## **CITY OF MILLERSBURG PLANNING COMMISSION MEETING**

- 1) File No: SP 21-02 Electrical Substation

TO: Matt Straite, City Planner  
FROM: Janelle Booth, Millersburg City Engineer  
DATE: April 7, 2021  
SUBJECT: SP 21-02 - Engineering Comments

CONSER ROAD SUBSTATION  
MILLERSBURG, OREGON  
GRADING PLAN  
DRAINAGE PLAN  
198328.001

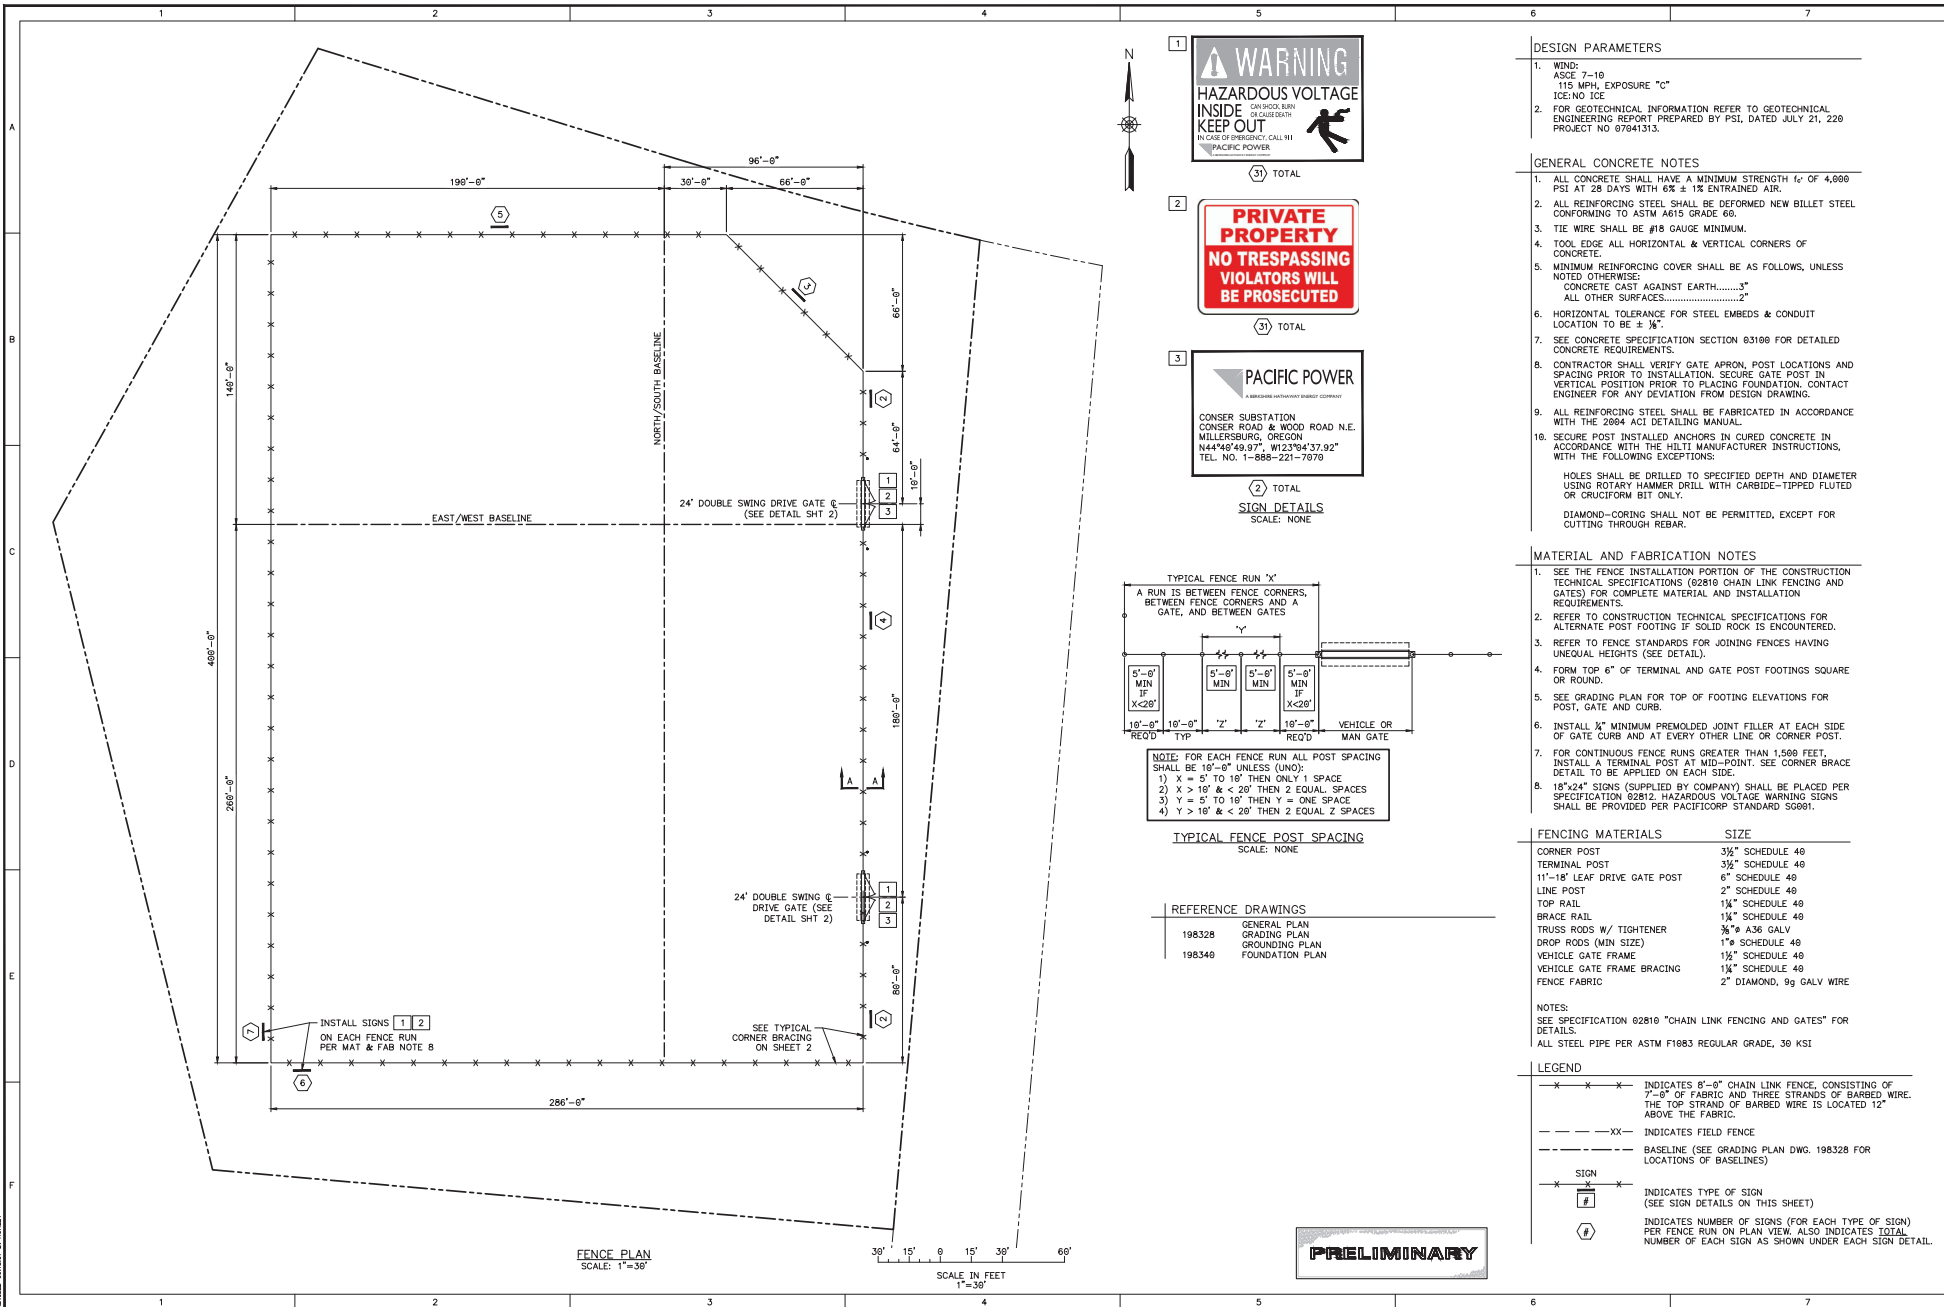
**ANALYSIS:** As outlined above, the applicant has not provided a drainage study. A 1200-C permit and a Millersburg permit for temporary erosion protection during construction will be obtained by the contractor prior to any ground disturbing activities. Conditions of approval have been added to assure development matches the requirement of the Code.

**ANALYSIS:** The application did not propose any landscaping. Because landscaping is required, a condition of approval has been added to require landscaping.

5. Stormwater detention and water quality facilities shall be designed as required to meet City standards. Stormwater calculations shall be submitted to the City Engineer for review and approval. Maintenance of detention basin and water quality facilities shall be the responsibility of the City.
6. The applicant shall submit engineering plans for all public improvements, including connections to public utilities (water, sewer, storm water, and streets) to City Engineer. The engineering plans shall conform to the Millersburg Engineering design standards, to the satisfaction of the City Engineer.

7. The applicant must obtain a City of Millersburg Erosion Control Permit and Grading Permit prior to construction.
8. Stormwater:
  - Obtain a 1200C Erosion Control Permit and a **City of Millersburg Erosion Prevention and Sediment Control Permit** for all the disturbed ground, both on and off-site that is in excess of one acre. The applicant shall follow the latest requirements from DEQ for NPDES 1200-C Permit submittals.

10. Prior to final inspection (certificate of occupancy), the applicant shall provide the City with a landscape plan showing the proposed landscaping for the site. Said plan shall be fully consistent with the requirements of 3.09.030(1)b.
11. Prior to final inspection (certificate of occupancy), the 30-foot setback spanning the entire frontage of NE Conser Road shall be landscaped in a manner that is consistent with the requirements of 3.09.030(1)b.
12. All required street signage and street lighting shall be approved by the City Engineer and installed.
13. Install the landscaping according to the landscape plan prior to occupancy or provide a bond, at the option of the City. Landscaping shall be completely installed or provide for erosion control measures around any disturbed or exposed areas.
